**Ultrasonic Phased Array
Assessment of the Interference
Fit and Leak Path of the
North Anna Unit 2 Control Rod
Drive Mechanism Nozzle 63 with
Destructive Validation**

Manuscript Completed: January 2012
Date Published:

Pacific Northwest National Laboratory
P.O. Box 999
Richland, WA 99352

G. Oberson, NRC Project Manager

Figure 5.10 PA Ultrasonic Data from Nozzle 63 Acquired After Second Brushing of the Nozzle ID. The front surface or nozzle ID echo is on the top and the interference fit echo on the bottom. The horizontal axis represents the 86 to 274 degree area and the vertical axis represents 360 mm (14.17 in.).

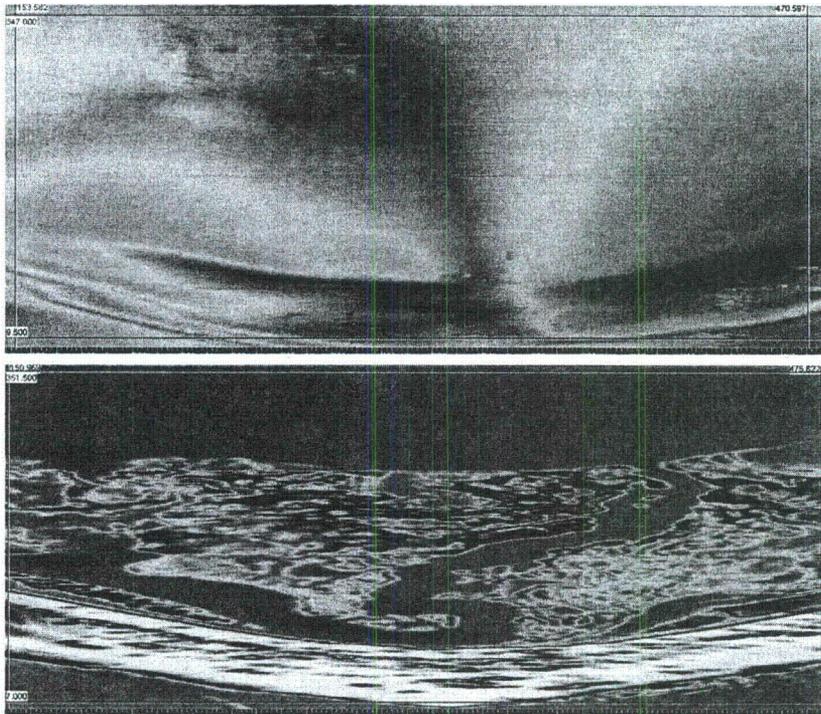
Comment [PG031]: Remove figure.

Figure 5.11 PA Ultrasonic Data from the Interference Fit in Nozzle 63 Acquired After the First Brushing of the Nozzle ID. The horizontal axis represents the full 360-degree area and the vertical axis represents 360 mm (14.17 in.).

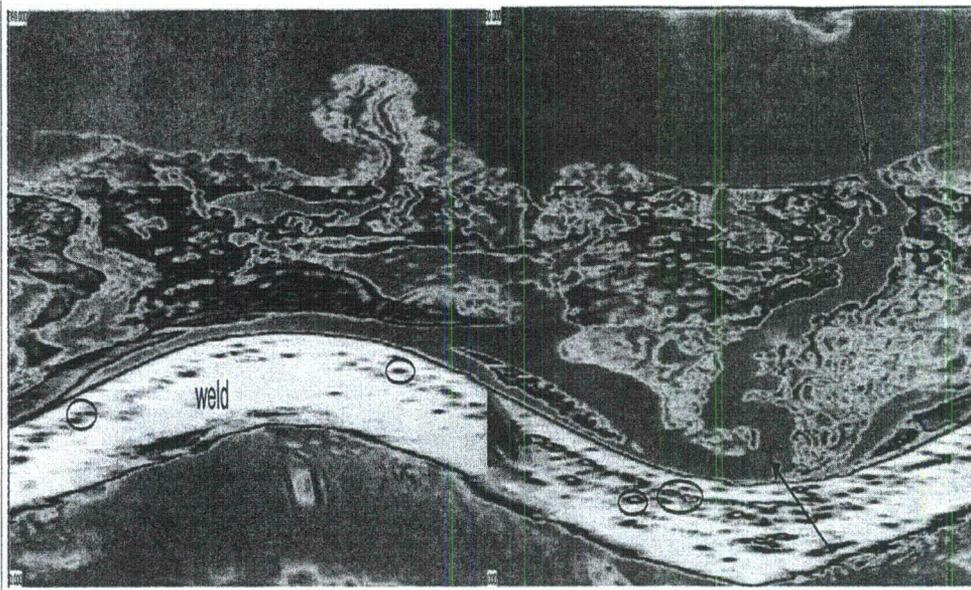
Comment [PGO32]: This is the important figure. Everything in the chapter up to this can be described by a few paragraphs of text at most.

Comment [PGO33]: Say that the arrows indicate the main leakage path. Don't circle the indications. Leave those for the section on the weld analysis. Maybe identify -90 on left and 270 on right for reference.

Figure 5.12 Interference Fit Data Image After First Brushing. The horizontal axis represents approximately 90 to 270 degrees. The vertical axis represents 360 mm (14.17 in.).

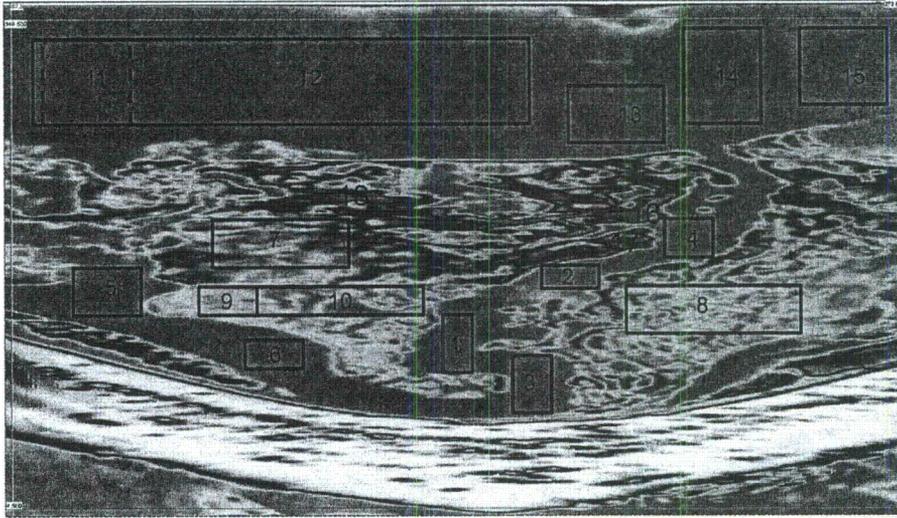
Comment [PGO34]: Make clear that the justification for suggesting that Region 1-6 is leakage path, Region 7-10 is interference fit, etc. is from the mockup results. Say that these suggestions need to be confirmed by destructive analyses.

Comment [PG035]: Say that the boxes correspond to regions for the amplitude analysis.

Figure 5.13 Interference Fit Data Image After First Brushing. The horizontal axis represents approximately -90 to $+90$ degrees. The vertical axis represents 360 mm (14.17 in.).

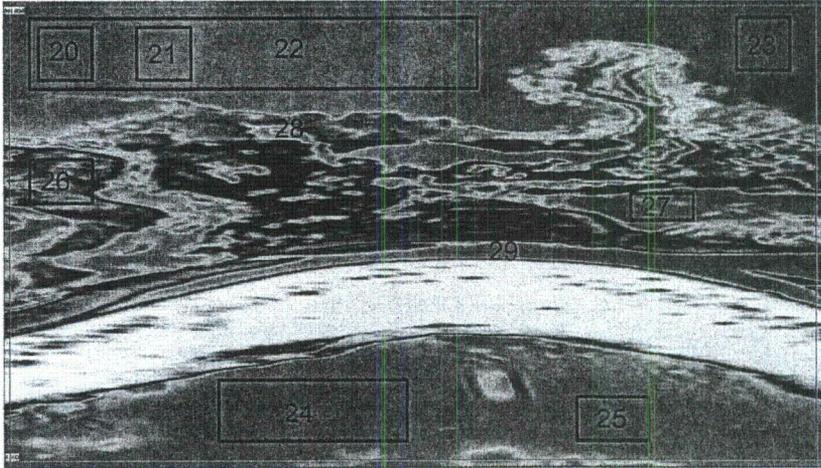
Comment [PG036]: See comment above.

Figure 5.14 Mean Amplitude Response from the Regions Indicated in Figures 5.12 and 5.13

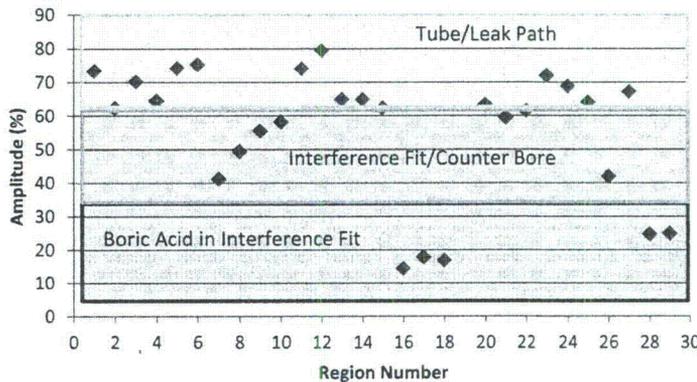
Comment [PG037]: This plot needs to be changed to better display the data. At a glance it looks like a random scatter of points because the region number has no correspondence to the amplitude. For example, it might display better if Regions 1-5 were selected as low amplitude locations, Regions 6-12 were selected as intermediate amplitude, etc.

Figure 5.16 A Tri-Color Representation of the Interference Fit Data

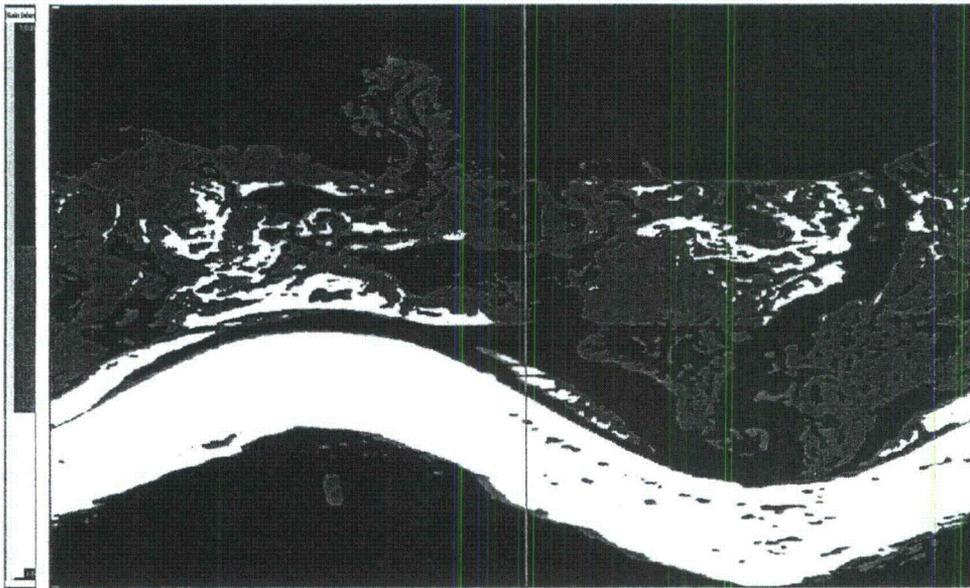
Comment [PGO38]: You may state what the 3 colors represent.
